Appl. No.: 10/709,677
Amdt. Dated: 7/3/2006
Reply to Office action of: 04/06/2006

AMENDMENTS TO THE DRAWINGS:

REMARKS/ARGUMENTS

Appl. No. 10/709,677
Amd. Dated July 3, 2006
Reply to Office action of 04/06/2006
Annotated Sheet Showing Changes

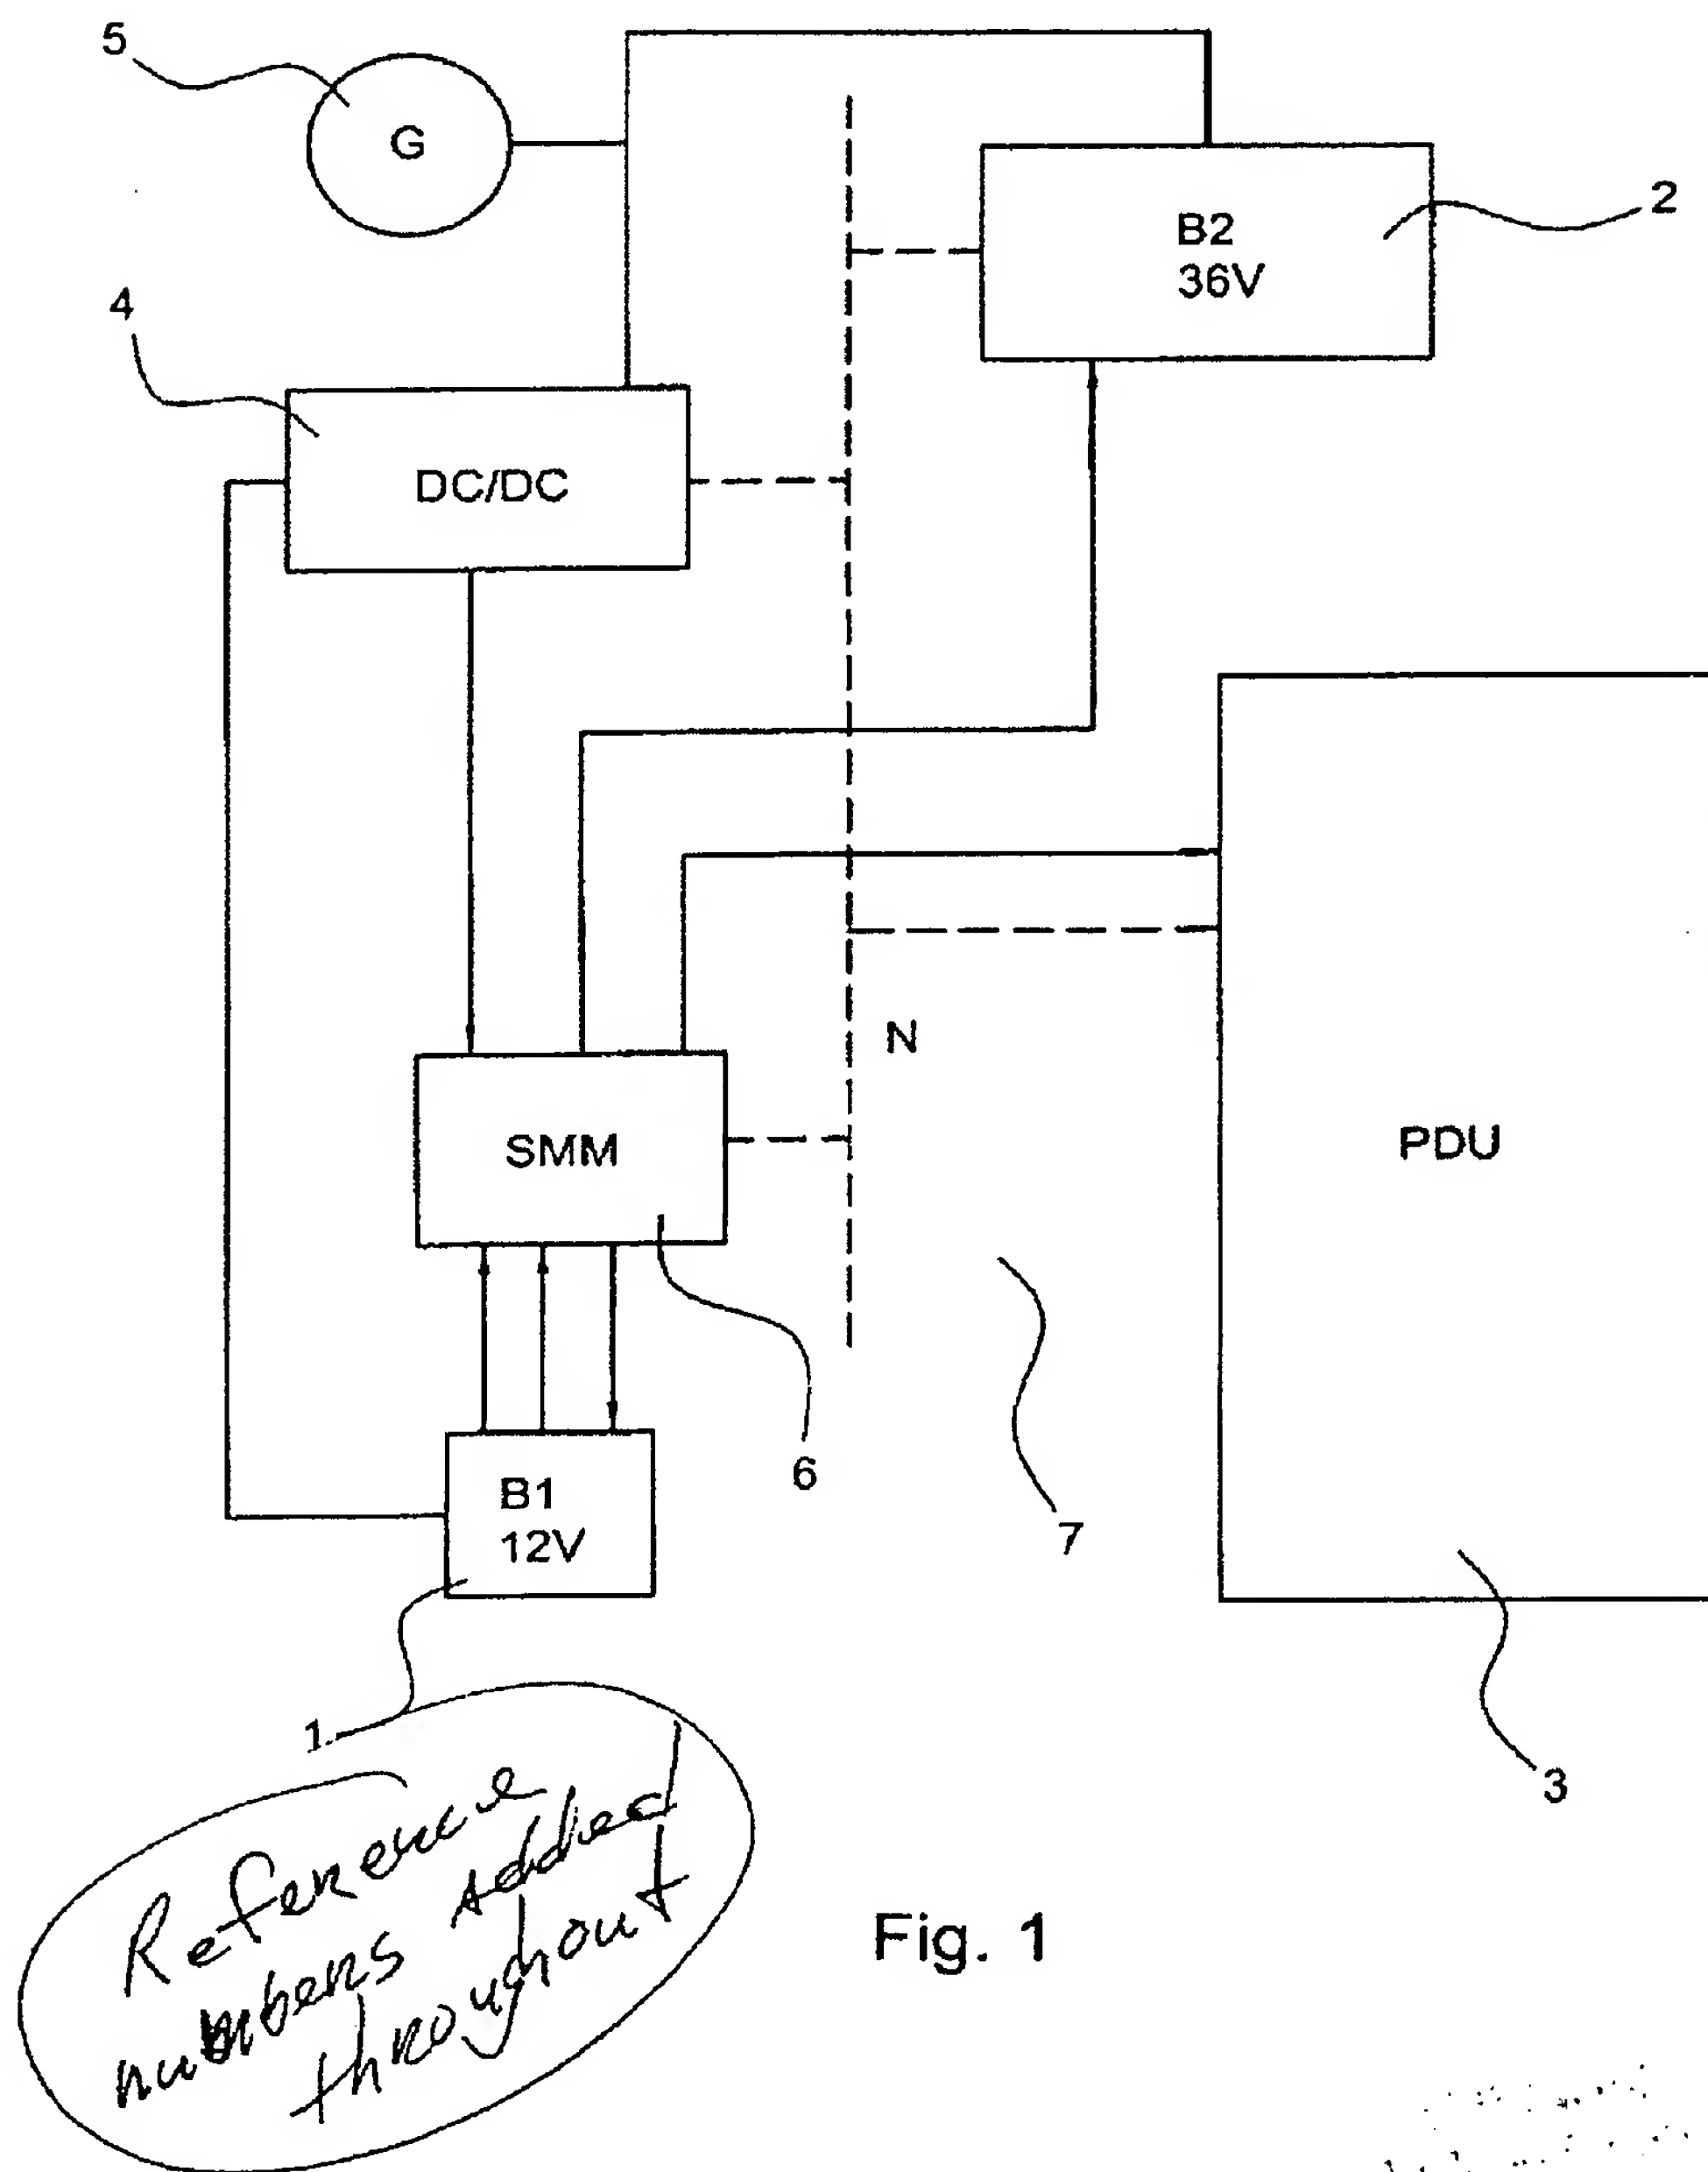
The attached sheet(s) of drawings includes changes to Figures 1 and 2. Figures 1 and 2 have been revised to incorporate numbers for all of the components shown in the drawings and to correct typographical errors in the text labels for these same components per the Examiners requirement.

In amended Figures 1 and 2, have had the labels corrected and reference numbers added as suggested by the Examiner.

The drawings were objected to by the Examiner because of improper labeling and lack of reference numbers. These objections are now overcome by the corrected new drawing sheets comprising Figures 1 and 2. In light of these new drawings Applicants respectfully request these objections to be removed.
